City of Albuquerque

RE: DRAINAGE PLAN FOR LOT 13A, BLOCK 7, REBONITO SUBDIVISION
RECEIVED JULY 30, 1992 FOR BUILDING PERMIT (J-23/D17)

DRAINAGE PLAN FOR LOT 13A

LOT 13A, BLOCK 7
WITHIN REBONITO SUBDIVISION
ALBUQUERQUE, NEW MEXICO

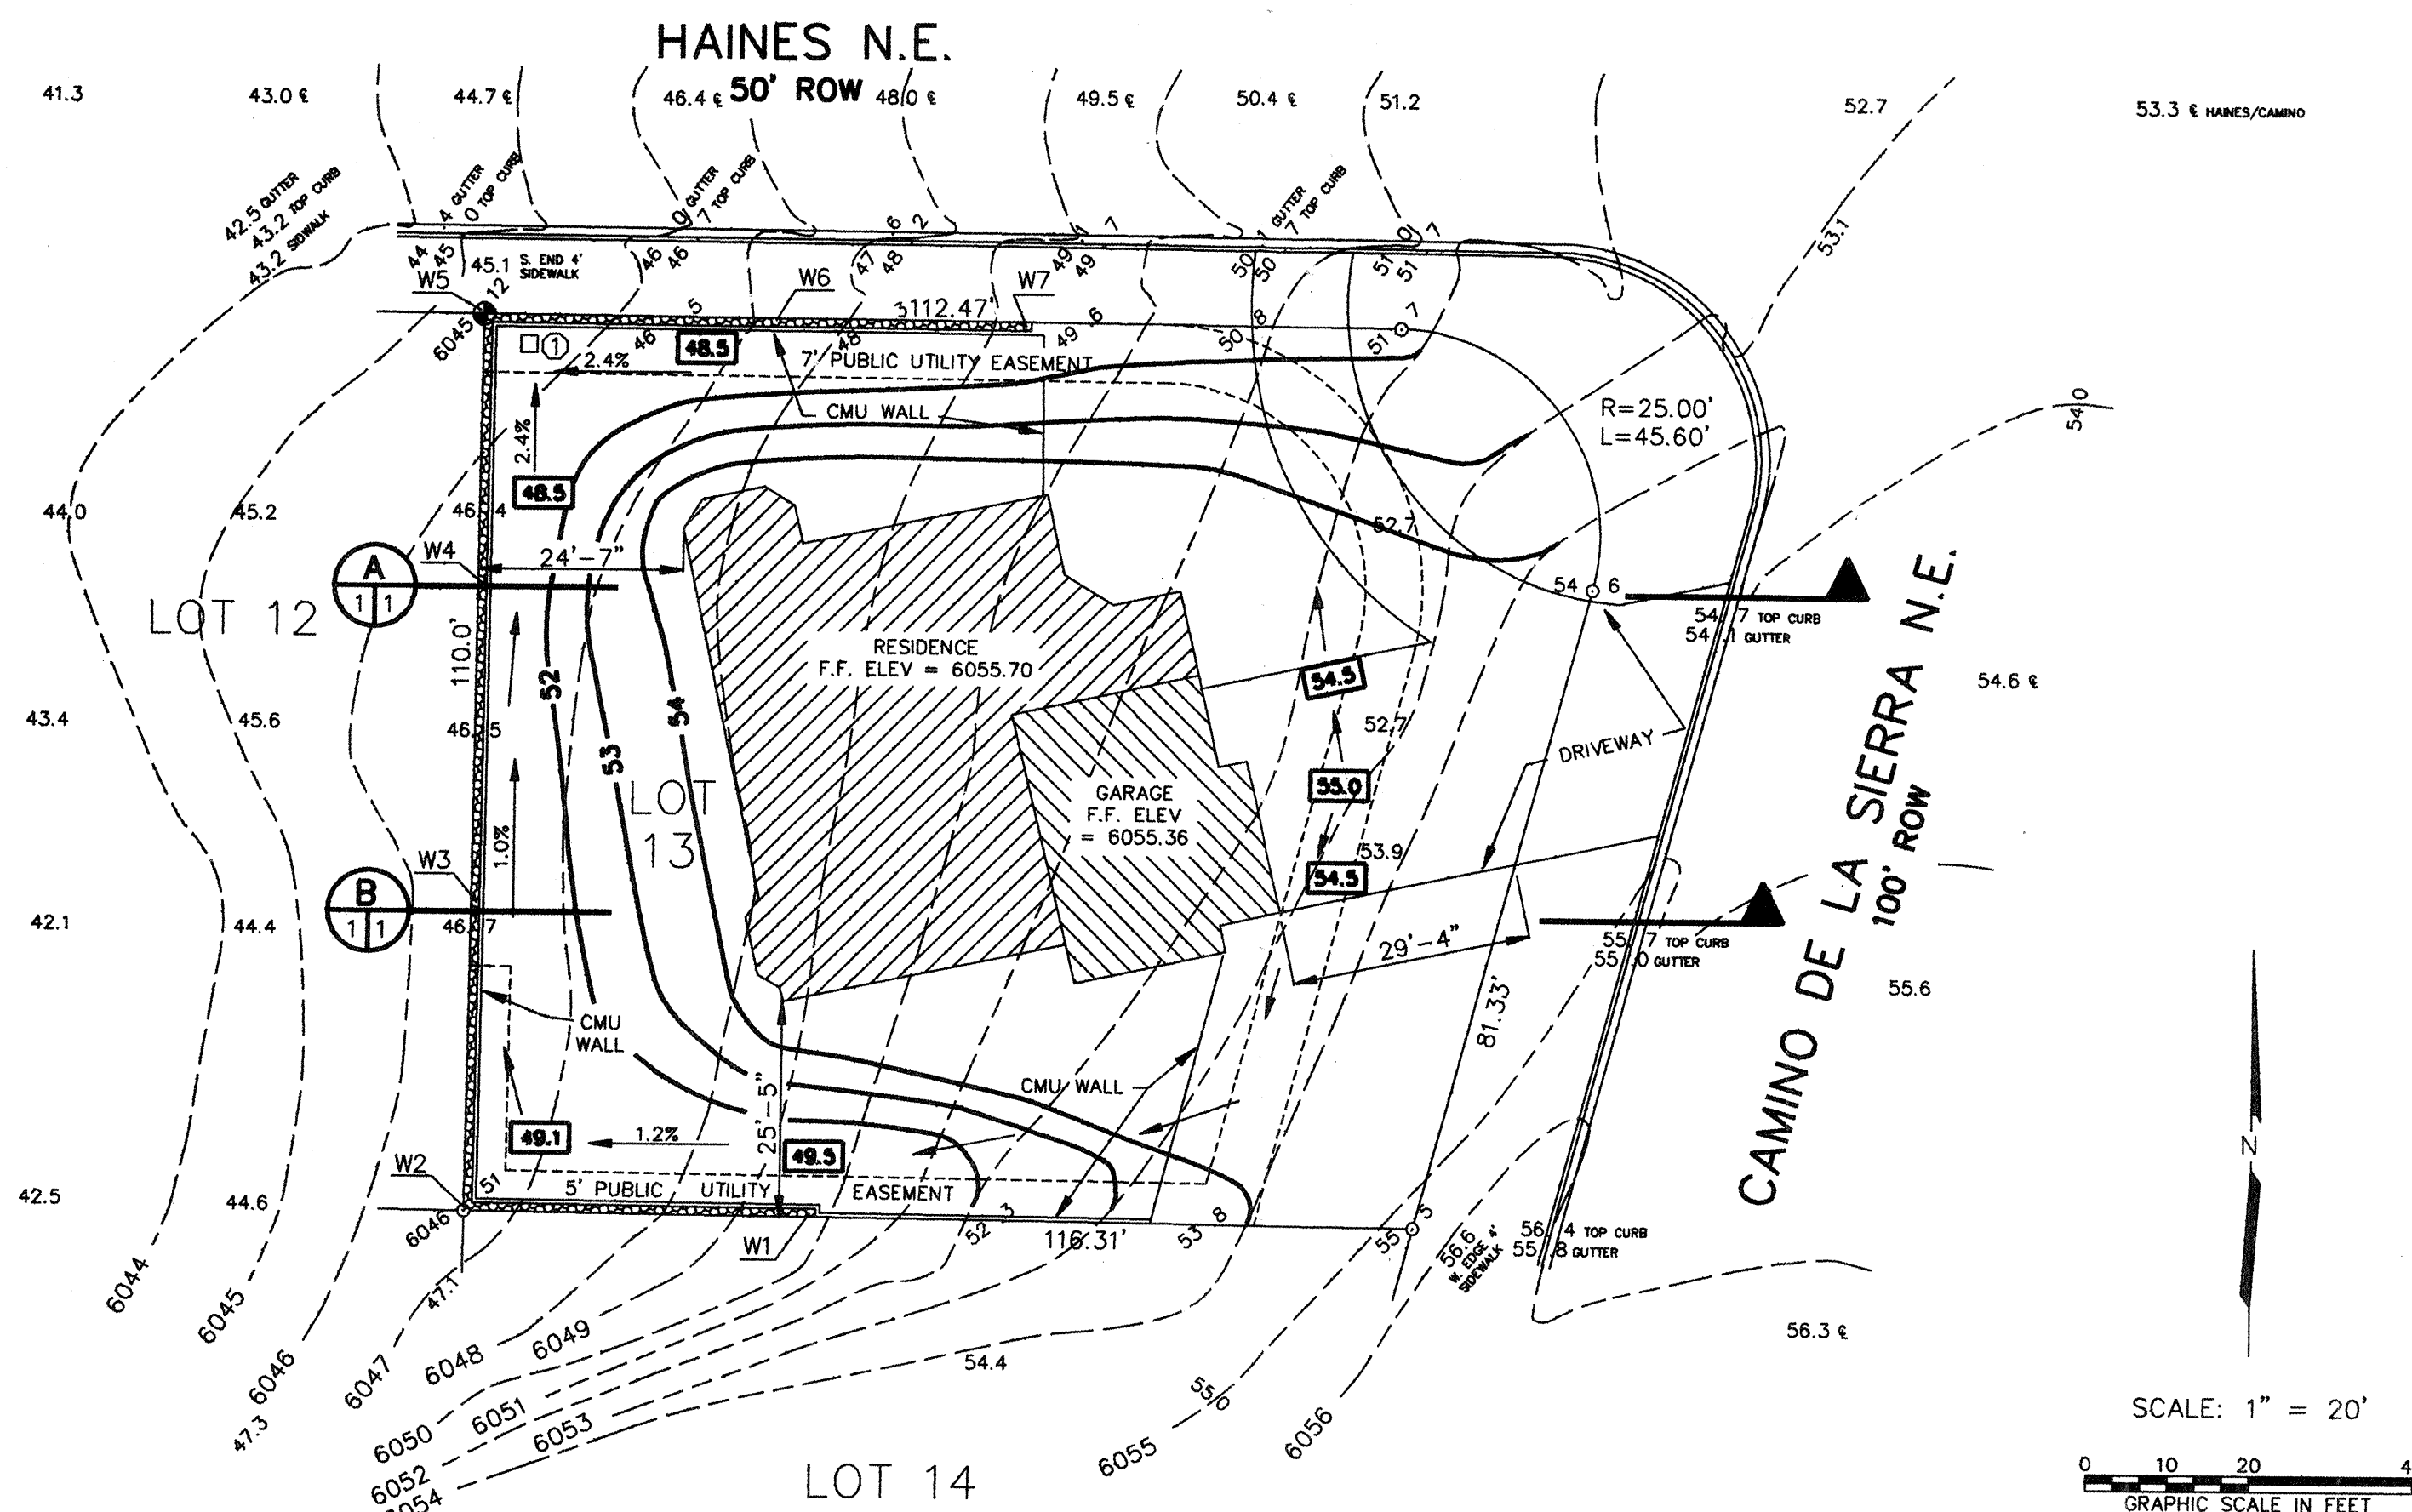
Based on the information provided, the plan is acceptable for Building Permit since you imported more than 500 cy of fill material.

Please be advised that the work within the right-of-way must be completed prior to the City performing final inspection on the building construction.
